BOARD OF DIRECTORS

BOARD OF DIRECTORS | December 4-5, 2015

The SCCA National Board of Directors met in Kansas City, Friday, December 4 and December 5, 2015. Area Directors participating were: John Walsh, Chairman, Dan Helman, Vice-Chairman, Todd Butler, Secretary; Bill Kephart, Treasurer; Dick Patullo, Lee Hill, Steve Harris, Bruce Lindstrand, Terry Hanushek, Tere Pulliam, Peter Zekert, Brian McCarthy and KJ Christopher and newly elected directors Arnold Coleman, Bob Dowie and Jim Weidenbaum.

Illustration of strut housing modification discussed in section g.4.:

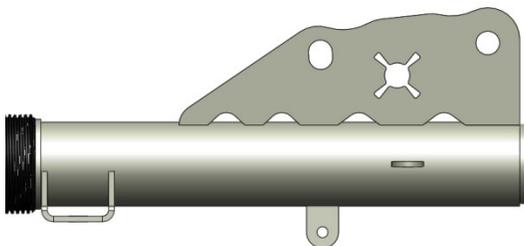
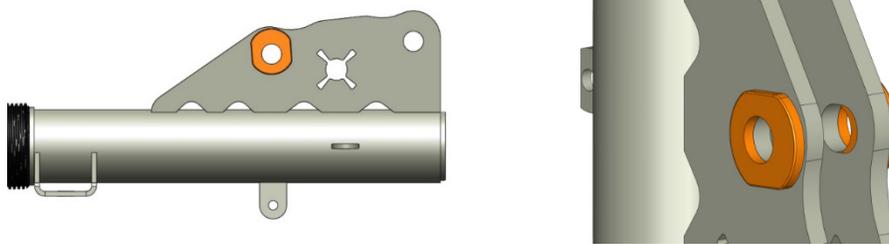
No machining of body to allow further travel. Caster: min. +6.35 max. +7.85 Camber plate PN MM5CC-5 or CCP197-05-09.

In Appendix M SMG Technical Regulations, section 2.i.1., remove the following language:

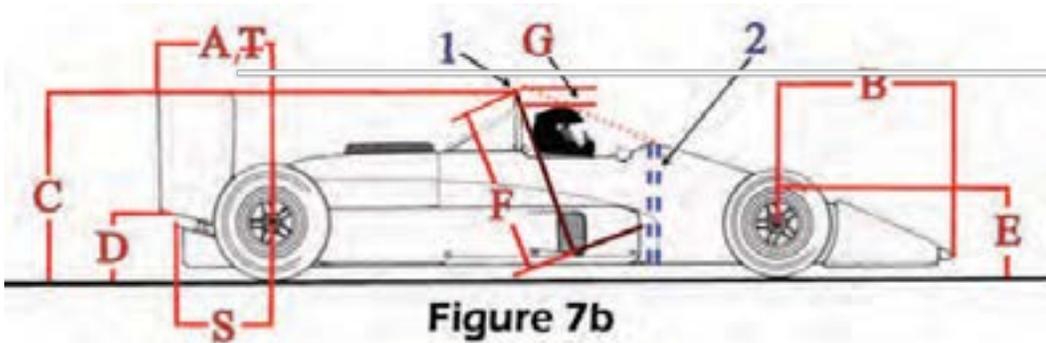
1. #18631 (James Blackwell) GCR Corrections
 In F1000 (FB), figure 7a, make the following corrections:
 Replace the dimension "R" in both locations with the letter "J"

In F1000 (FB), figure 7b, make the following correction:
Delete the letter "T"
